Headlight Rocker Switch Failure

CX, CXN

SC342, Headlight Rocker Switch Failure

(June 2009)

Figure 2 — Disconnect 6Pin Connector

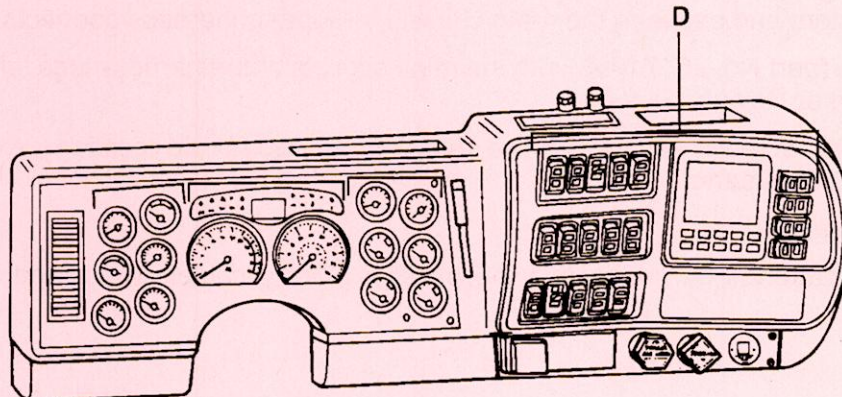
3. Disconnect the 6-pin D-panel connector.

4. Connect the headlight jumper harness (part No. 41MR41165M) between the cab 6-pin cab-to-D-panel harness connectors.
5. Install the relays (part No. 25171095) into the relay sockets of the harness legs labeled "Head Lamp Relay" and "Marker Relay."

6. Using self-tapping screws, secure the two relays to an accessible location on the cab bulkhead behind the instrument panel.
7. Secure the jumper harness ring terminal to the cab ground stud located behind the ABC (gauge cluster)-panel.

Figure 4 — Disconnect 4-Pin and 30-Pin Connectors

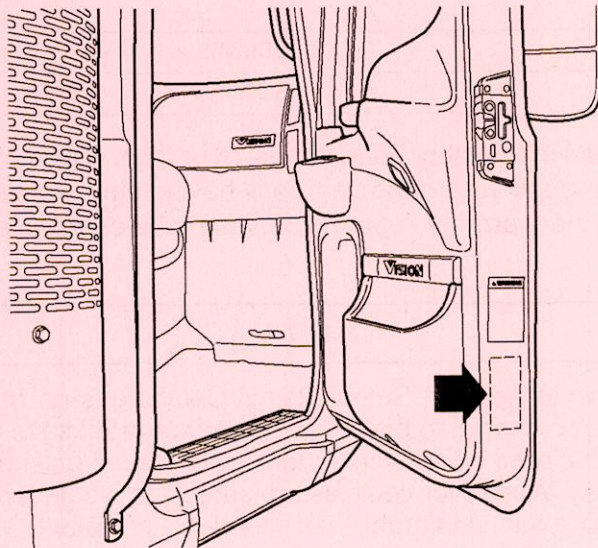
3. Disconnect both the 4-pin and 30-pin D-panel connectors.

4. Install the headlight jumper harness (part No. 41MR4166M) between the 30-pin chassis-to-D-panel harness connectors and between the 4-pin chassis-to-D-panel harness connectors.
5. Install the relays (part No. 25171095) into the relay sockets of the harness legs labeled "Head Lamp Relay" and "Marker Relay."
6. Using self-tapping screws, secure the two relays to an accessible location on the cab bulkhead behind the instrument panel.
7. Reinstall the D-panel.
8. Reconnect the batteries by connecting the positive battery cable(s) first, and then the negative cable(s).
